CODE COMPLIANCE CERTIFICATE

Consent No(s): 190555, 190555A, 190555B

RFI Response Sheet – 12.08.2019

8 Hughes St, Waikanae

Drawing: **Plumbing & Drainage Plans**

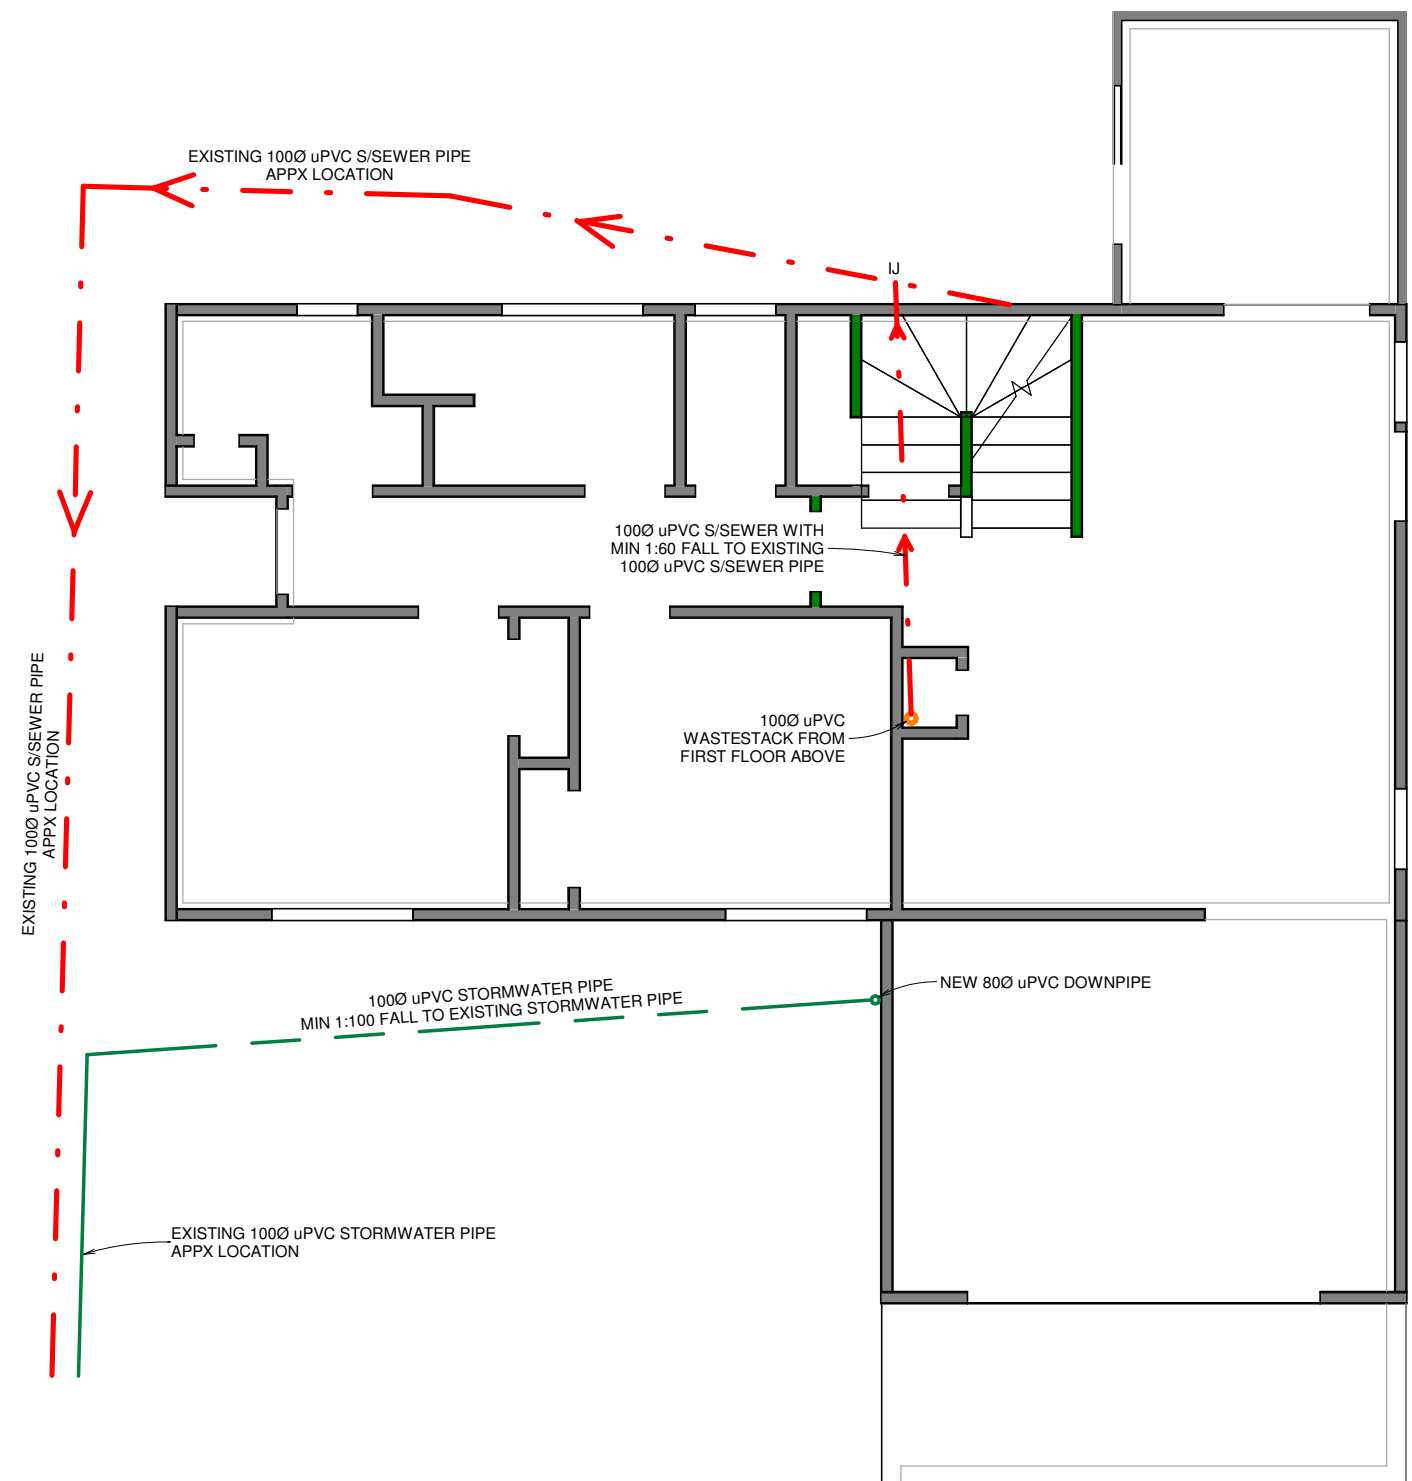
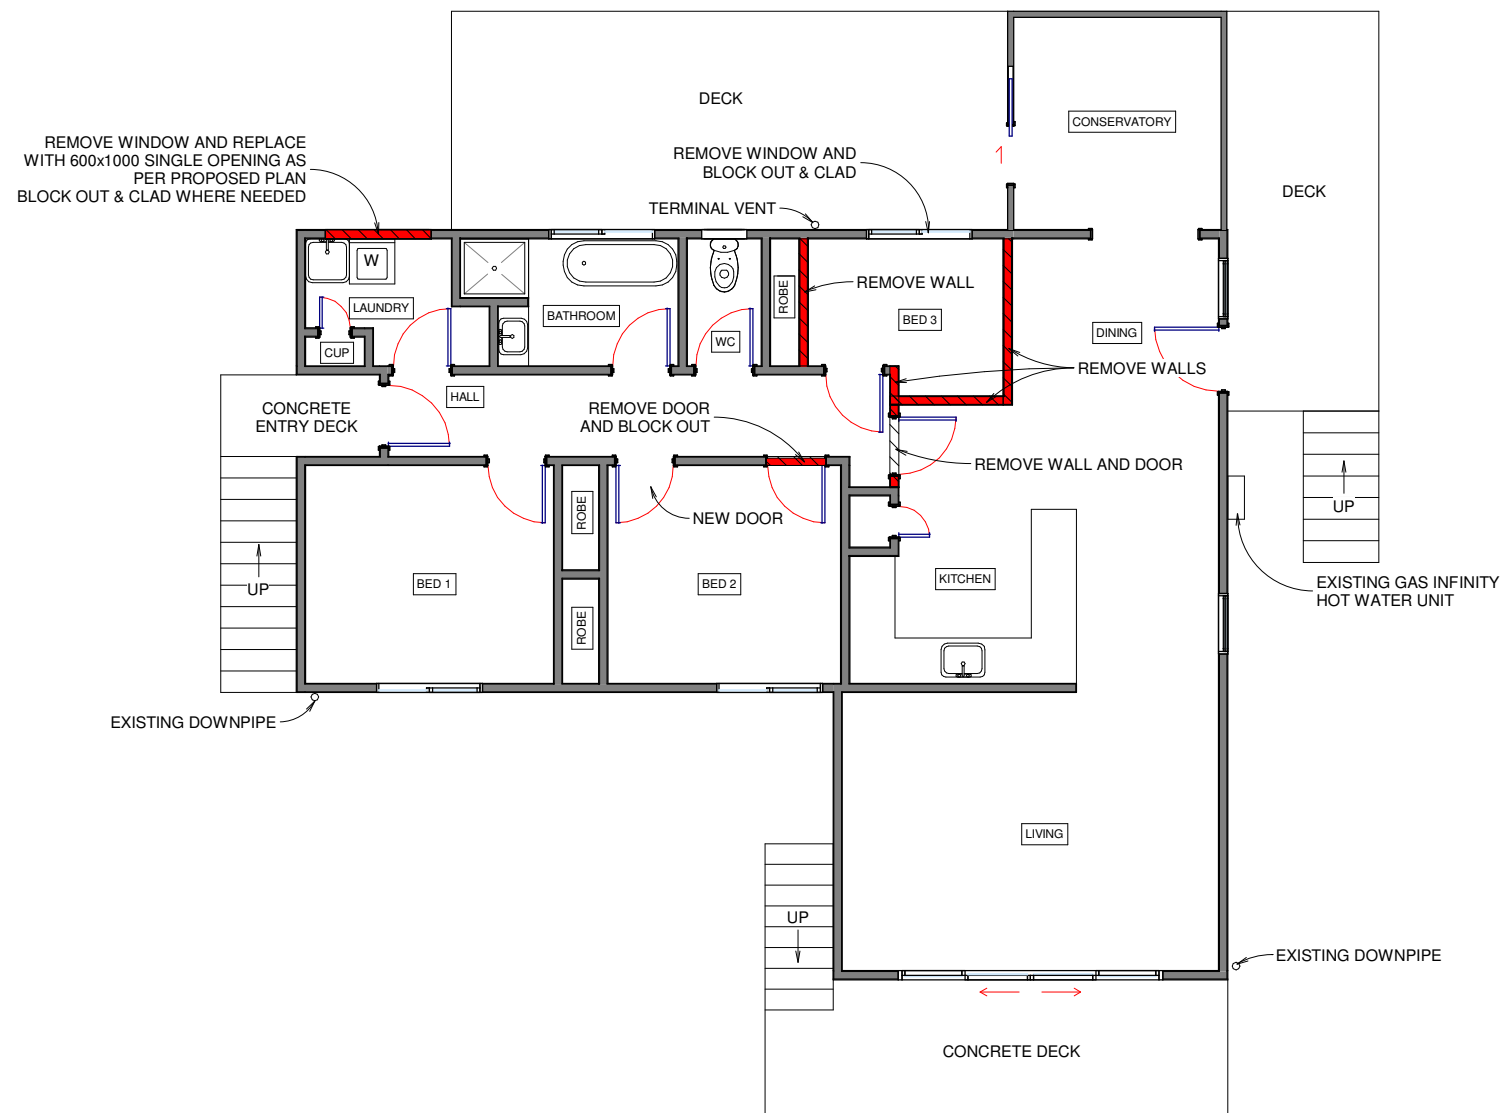
There was no change to the existing drainage and this is shown on the plumbing and drainage plan on record sheet 150. The inspection undertake by the council was viewed and signed off as part of the pre-line process.

Sheet No:
Revision:
RFI 1
110

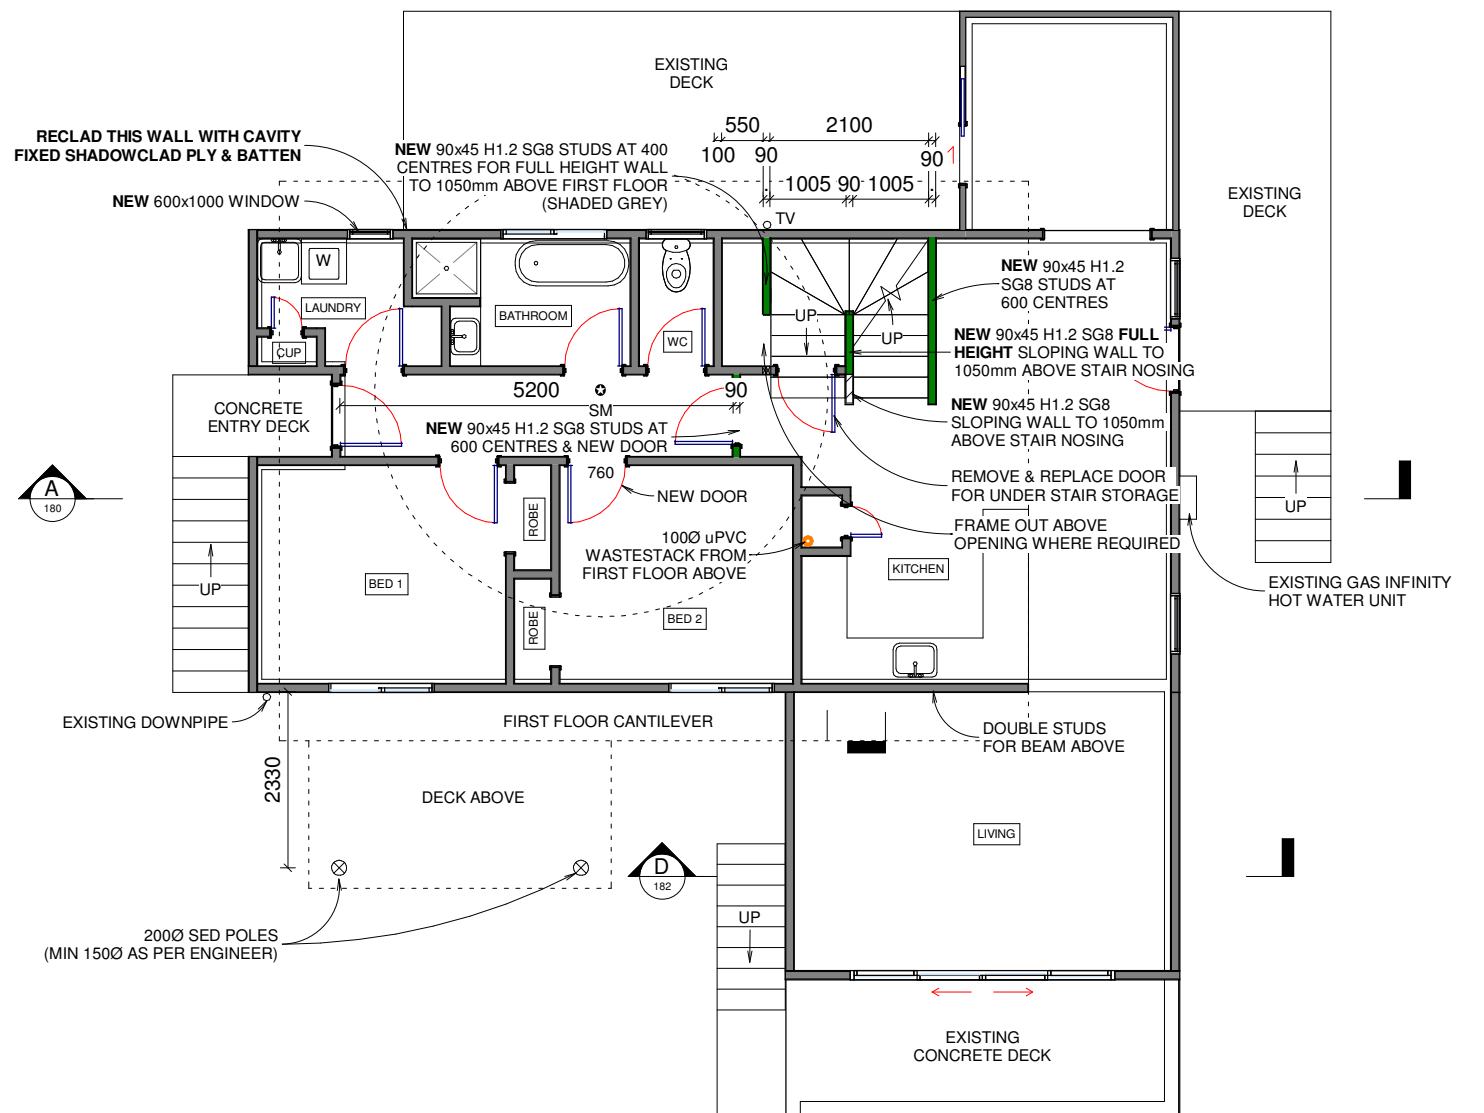
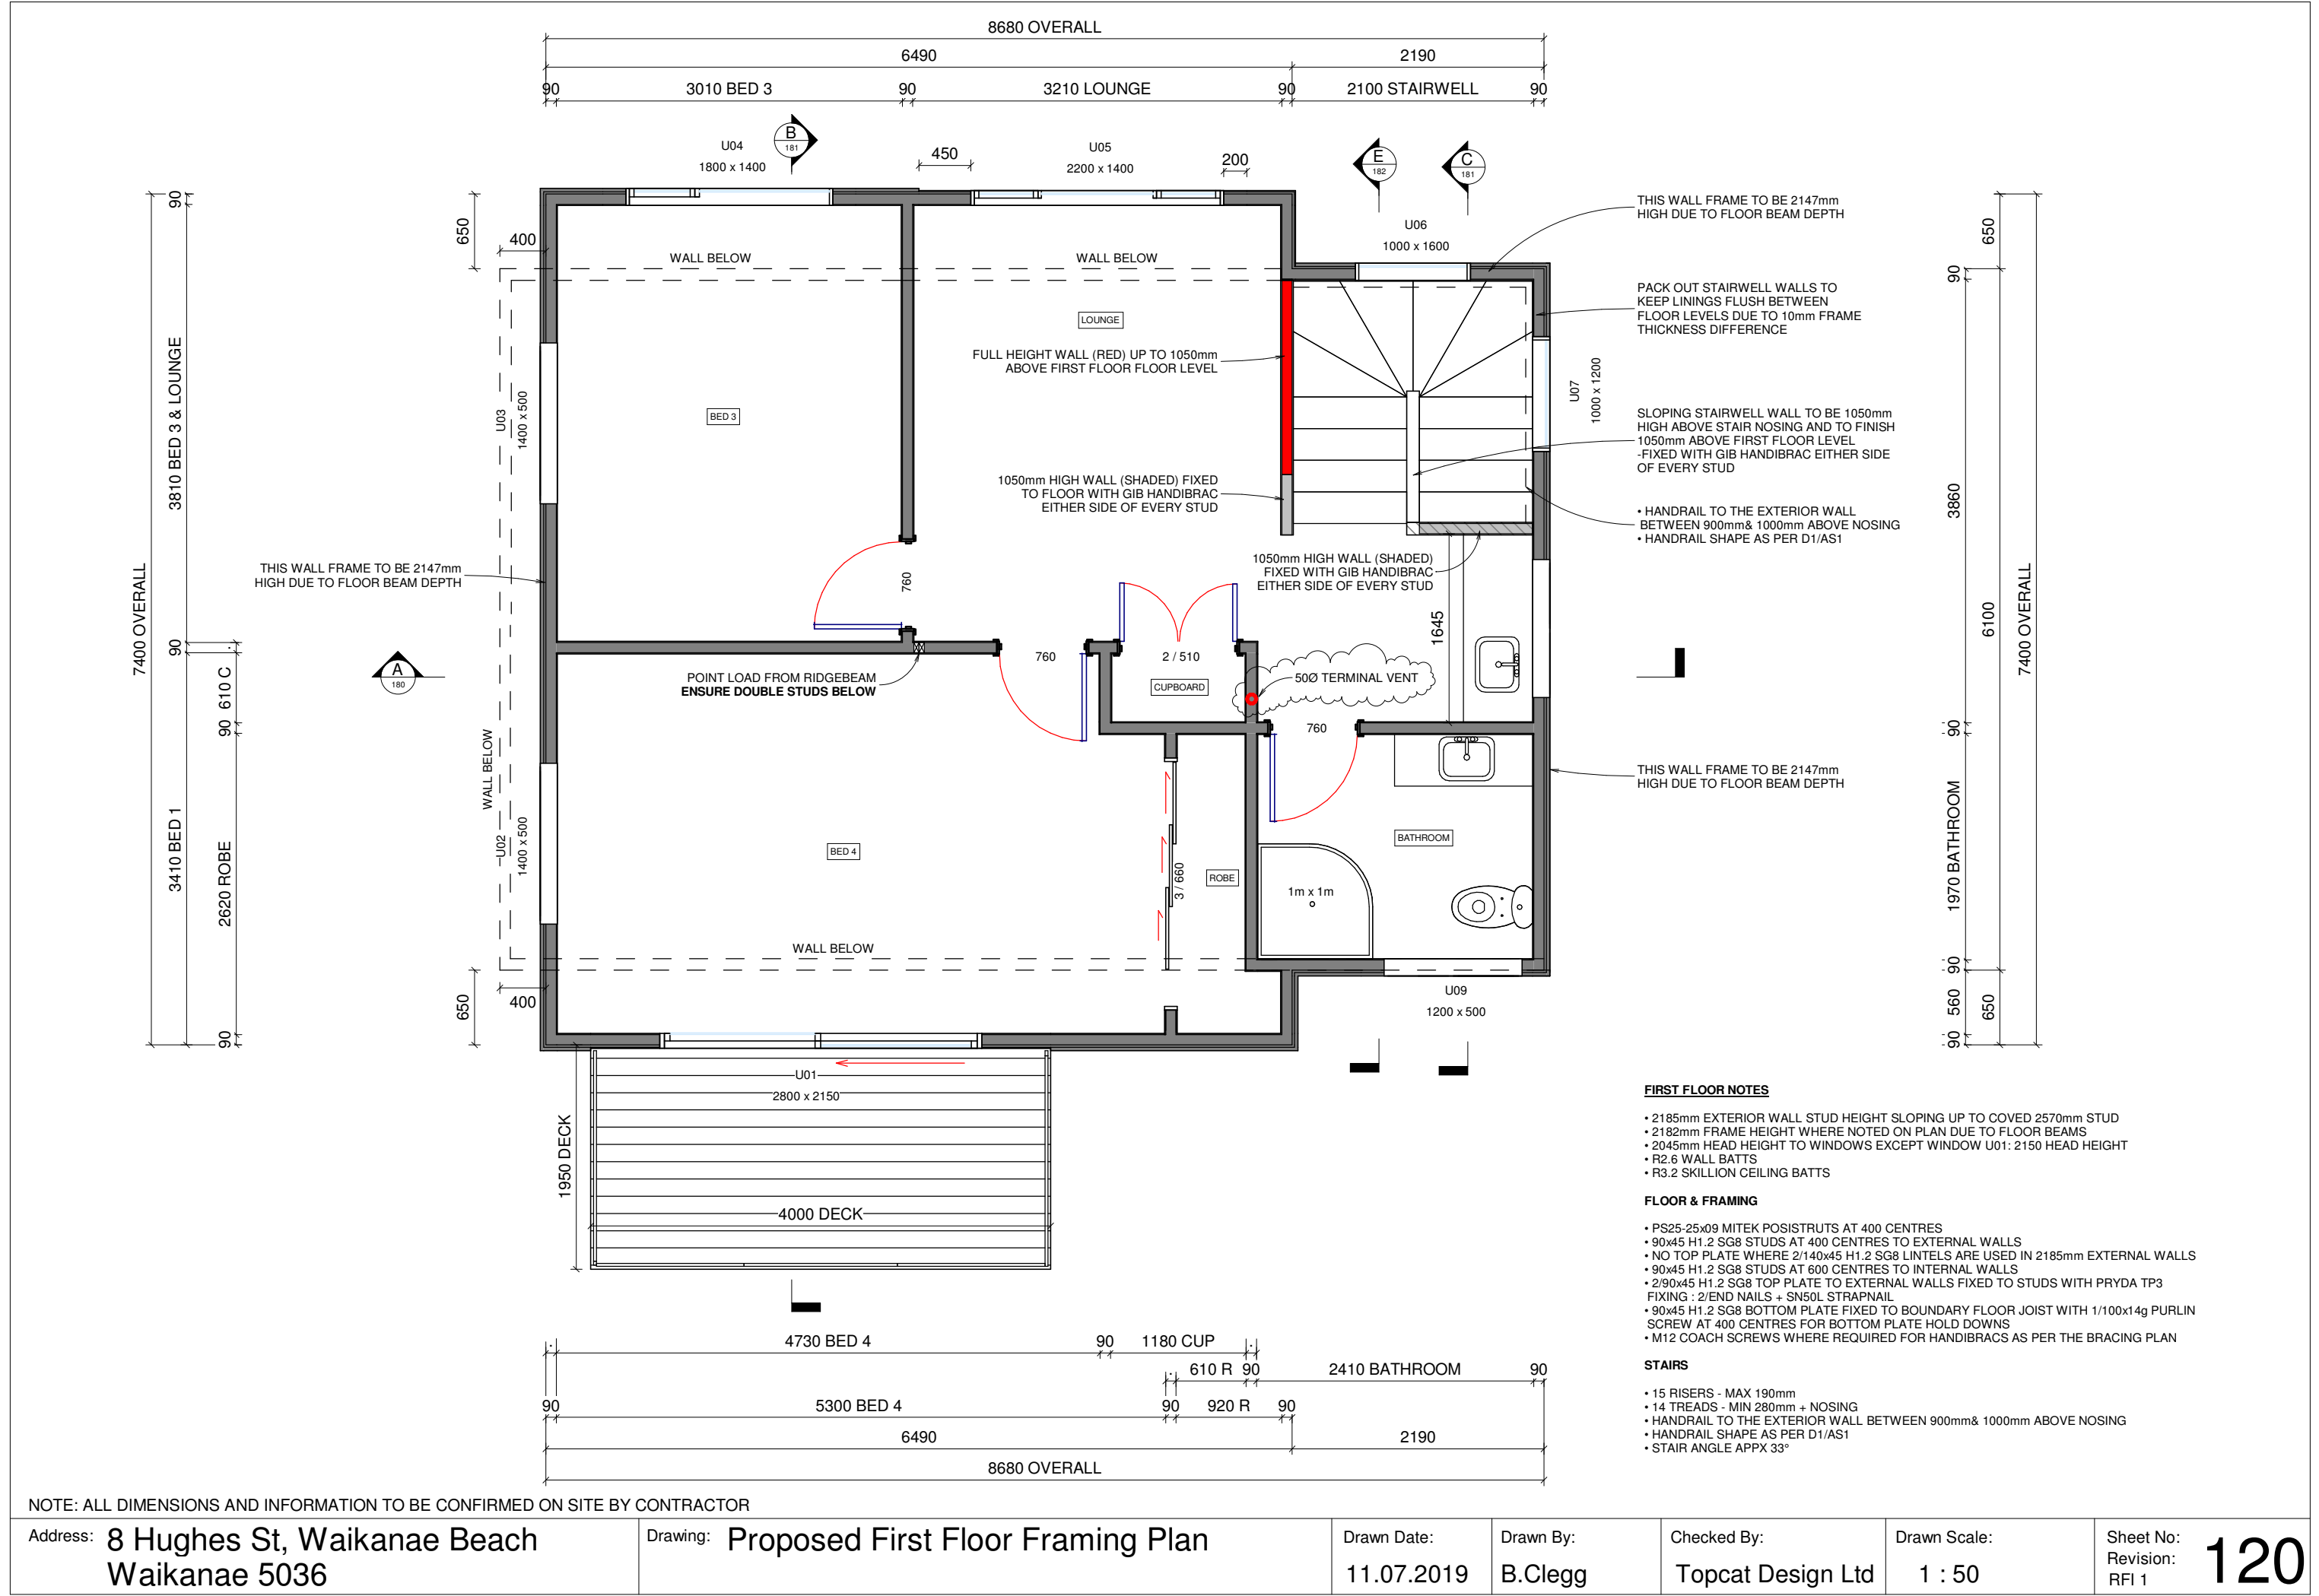
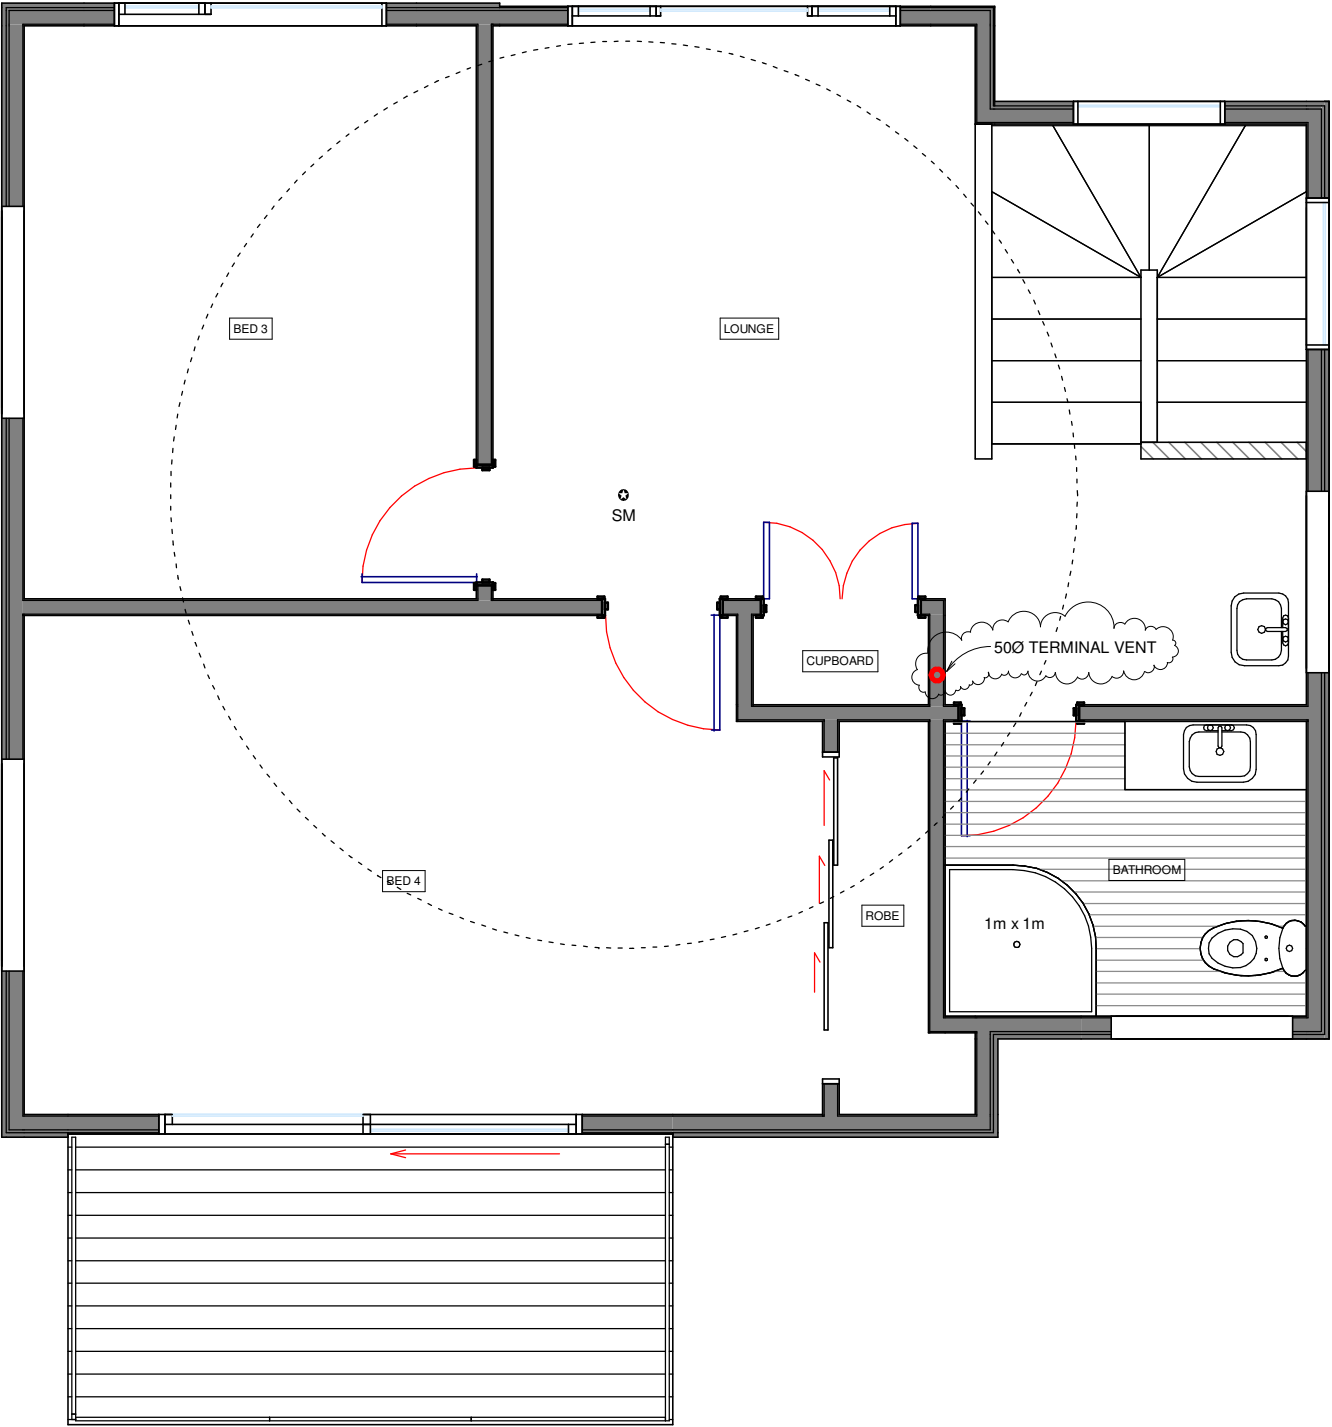
1. Provide the PS1 for the Juralco EDGE proprietary face fixed balustrade system.
Please see the attached PS1.
2. Indicate smoke detector to both levels.
Smoke detectors have been shown on the proposed first floor. Please see the attached updated sheet 110 with the smoke detector shown in the hallway on the proposed plan.
